# Springpole Project Independent Geotechnical and Tailings Review Board

**Re: Springpole Project  
Co-Disposal Facility  
Review of Pre-Feasibility Design Update Report**

**TO:** Michael O’Flaherty, Steve Lines (FMG)  
**FROM:** Ganan Nadarajah and David Bleiker (WSP)  
**CC:** Marci Mehl (WSP)  
Shane Hayes, Meghan Bertenshaw (FMG)  
**SUBJECT: CDF Pre-Feasibility Design Update Report  
Clarification and Responses to IGTRB Review Report**  
**PROJECT NO.:** CA-EI-OMGM2215  
**DATE:** October 10, 2024

**Re: Springpole Project Co-Disposal Facility Pre-Feasibility Design Update Report  
Response to CDF Clarification and Responses to IGTRB Review Report**

Fig. 1. Isometric view of the proposed transition between the North and South Cells

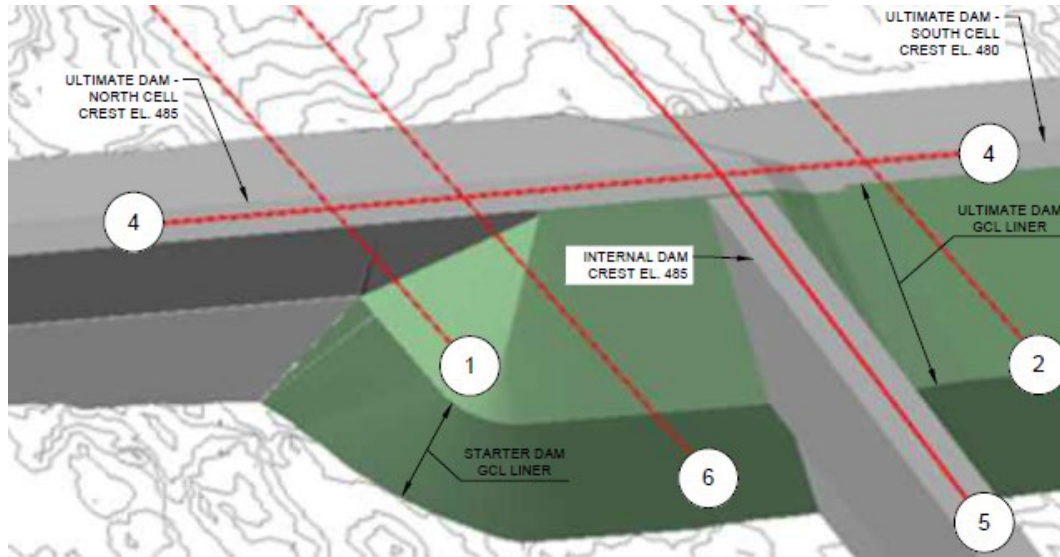
The update report presents details of the North/South Cells transition. The GCL-lined upstream slopes of the South Cell dams are proposed to be extended for a distance into the East and West dams of the North Cell Perimeter Dams to lengthen the seepage path, which would be through deposited tailings. The seepage path through the North Cell embankment would be eliminated. The IGTRB considers that the revision should provide adequate seepage control. The geometry of the transition zone, shown in Figure 1 below, is complicated and will require careful control during construction. The extent of the lined zone extending into the North Cell should be optimized in the next stage of design, employing 3D seepage modeling with sensitivity analyses varying hydraulic properties.

*IGTRB: The extent of the lined zone extending into the North Cell should be optimized in the next stage of design, employing 3D seepage modeling with sensitivity analyses varying hydraulic properties.*

WSP: Agreed. It is planned to perform 3D seepage analyses, including sensitivity analyses, during permitting and later design stages to define and optimize required extension of the lined South Cell dam into the North Cell.

Fig. 2. Proposed typical section of the North Cell dams.

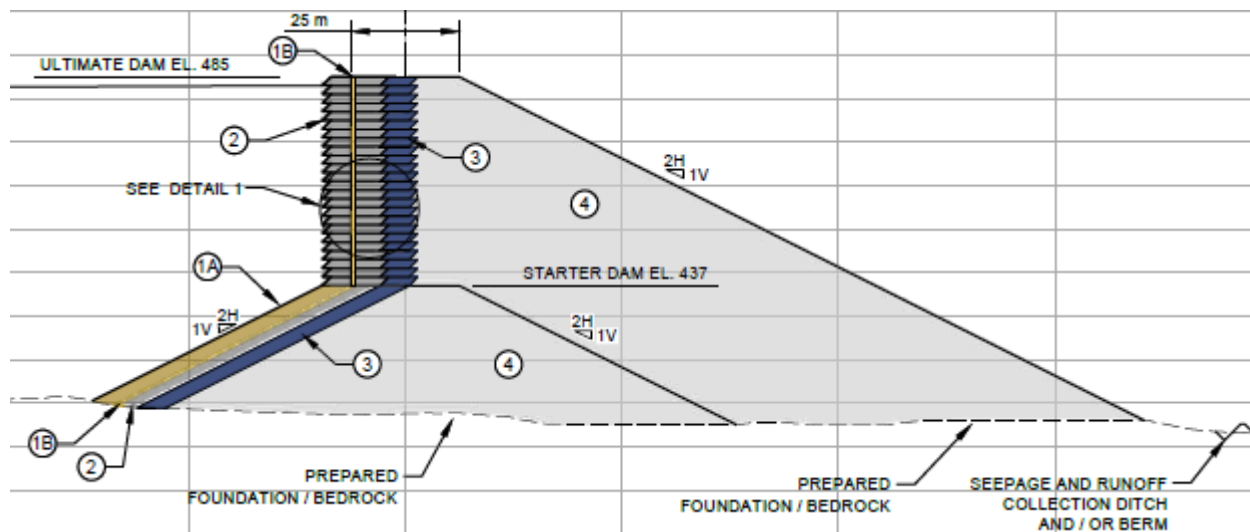
A revision has also been made to the design section of the North Cell dams. Above the Starter Dam the embankment is proposed to be raised by centreline construction, with a vertical transition and filter zone surrounded by transition zones upstream and downstream. The transition zones could be raised in thin lifts to facilitate near-continuous crest raising year-round. The filter zone could be constructed by trenching through the transition zone and backfilling the trench with filter material. The typical section is shown on Figure 2. The IGTRB supports this design section. There has been no revision to the South Cell Perimeter Dams from the previous version of the PFS design.

With the expected low phreatic surface, there will be minimal hydraulic gradient across the filter and transition zones, with little flow that could carry tailings into the rockfill. This may allow simplification of the filter and transition zones, perhaps to a single, well graded material such as the Low RQD NAG (“Sand Zone”) material from the open pit. More characterization of the Sand Zone should be carried out in the next phase of design.

WSP: Agreed. Additional characterization of the Low RQD Sand Zone is planned during permitting and future design stages and will help refine and optimize the transition and filter zones design.

Fig. 3. Seepage Analysis Model, Typical Section North Cell Perimeter Dam

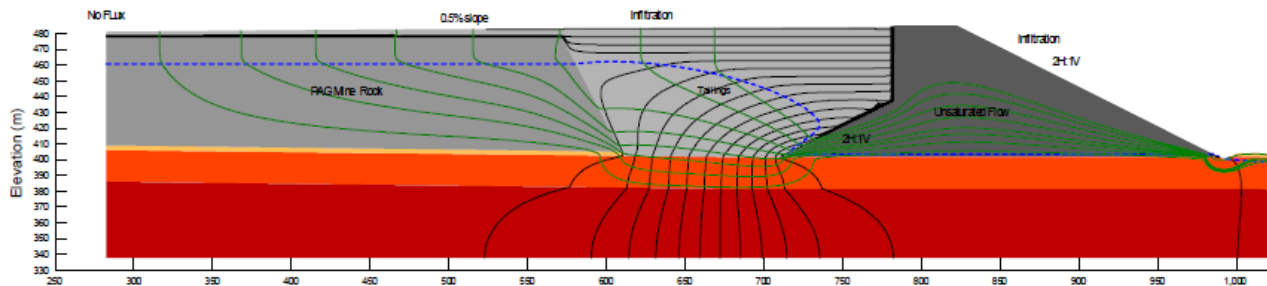
Figure 3 below shows the results of a seepage analysis through the North Cell dams. This analysis shows that the phreatic surface is expected to be very low, with seepage exiting through the shallow bedrock zone. This is an expected outcome, given that the upstream slope of the starter dam is unlined. The IGTRB cautions that seepage may be higher during first filling, before the tailings beach develops. It may be prudent to provide upstream lining to some height along the topographic low on the SE side of the North Cell to prevent excessive seepage in this location where water may initially pool.

WSP: Agreed. North Cell starter dam segments will be considered in more detail at later design stages with the modelling proposed in Item 1. This will include consideration of a suitable low permeability zone to control seepage and facilitate water management at start-up. Active pumping from North Cell to South Cell would also be required at start-up. As IGTRB noted, it is expected that the tailings beach zone, once established, will provide the low permeability zone reducing the seepage across the North Cell dam.

As discussed above, additional seepage analyses (including sensitivity analyses) will be performed at each subsequent design stage considering potential range of hydraulic conductivity of tailings, bedrock, filter and protection zones to assess phreatic surface variation across North Cell dam and optimize the design as required to meet the mitigation requirements.
